Planning Commission Minutes  
September 26, 2024

5. (SPUD-1662) Application by MILU, LLC to rezone 2416 North Western Avenue from NC Neighborhood Conservation, UD Urban Design Overlay, and TT Twenty-Third Street Uptown Corridor Overlay Districts to SPUD-1662 Simplified Planned Unit Development, and UD Urban Design Overlay Districts. Ward 2.

**STAFF REPORT**  
**The City of Oklahoma City**  
**Planning Commission**  
**September 26, 2024**

**(SPUD-1662) Application by MILU, LLC to rezone 2416 North Western Avenue from NC Neighborhood Conservation, UD Urban Design Overlay, and TT Twenty-Third Street Uptown Corridor Overlay Districts to SPUD-1662 Simplified Planned Unit Development District. Ward 2.**

1 Architectural Site & Landscape Plan  
1/8" = 1'-0"

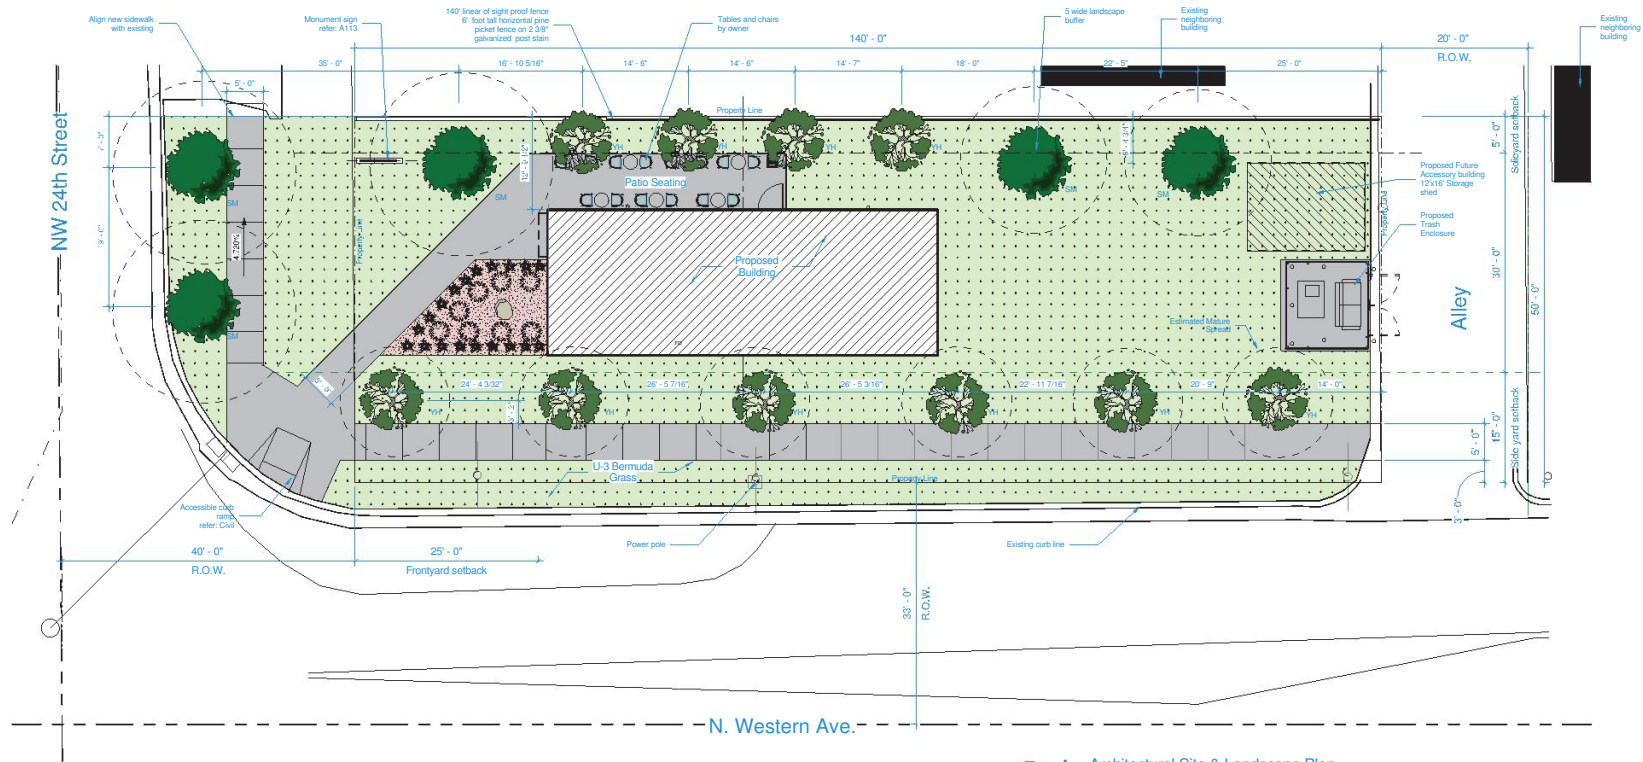
10. Site plan needs to show location of dumpster.
